ADDENDUM NO. 1

PROJECT: ADA FISHING PIER
SOUTH SANDSTONE FISHING ACCESS SITE

FWP PROJECT #: 7133735

DATE: September 11, 2014

SLAB CONTROL JOINT DETAIL
PLAN VIEW

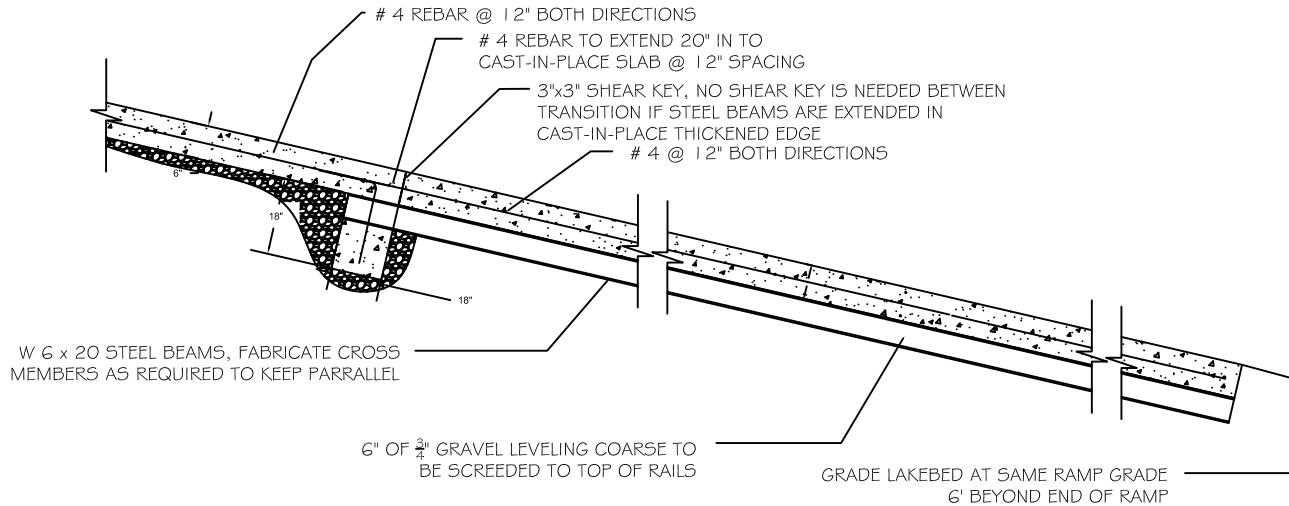
3) Modification – Plan Sheet 6 of 6, Slab Control Joint Detail:

Revise the saw cut control joint spacing to 6' square instead of 8'.

Cast-in-Place Ramp Details
South Sandstone FAS (near Plevna, MT)

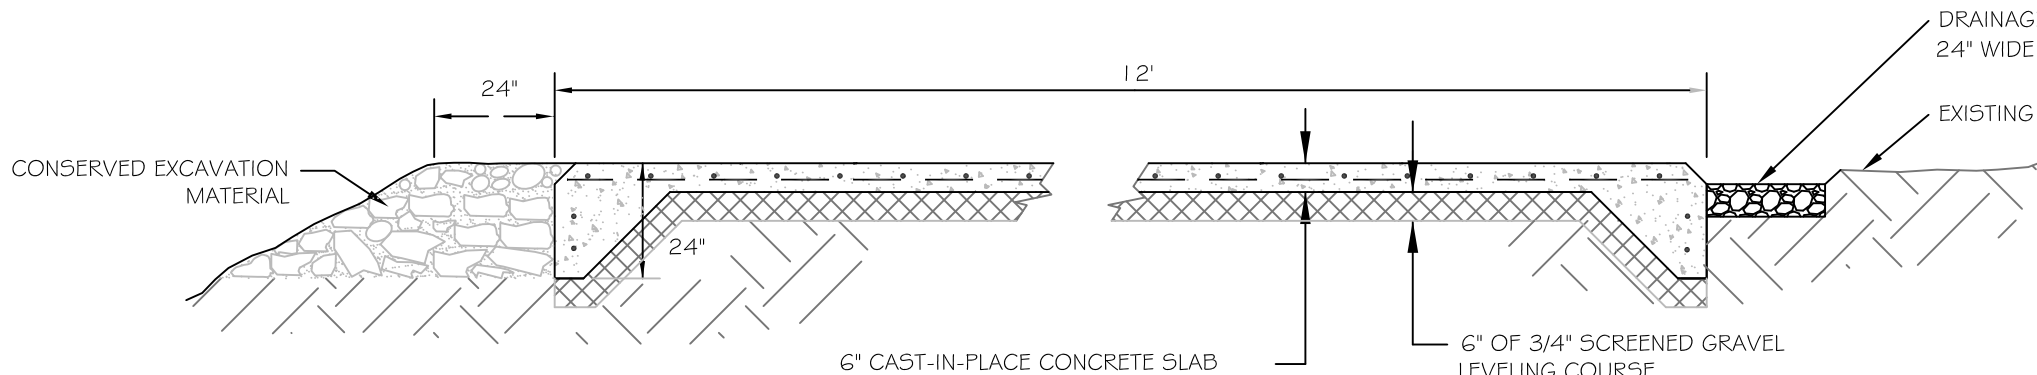
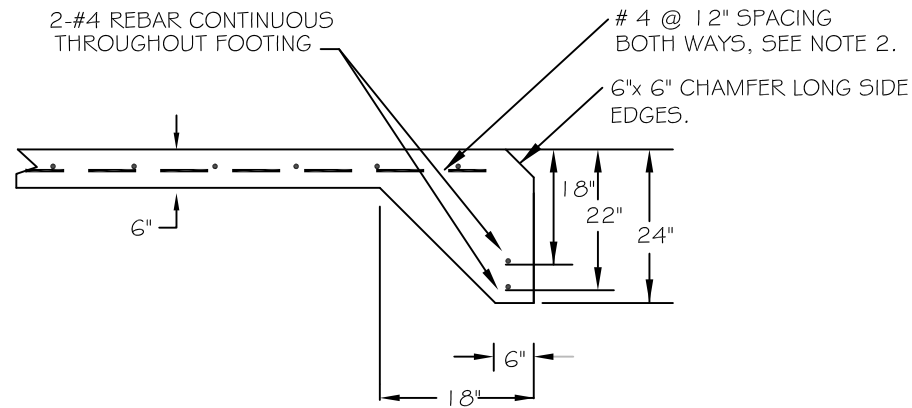
4) Modification – Plan Sheet 1 of 1, Cast-in-Place Concrete Boat Ramp Details:

Addition to project drawings.
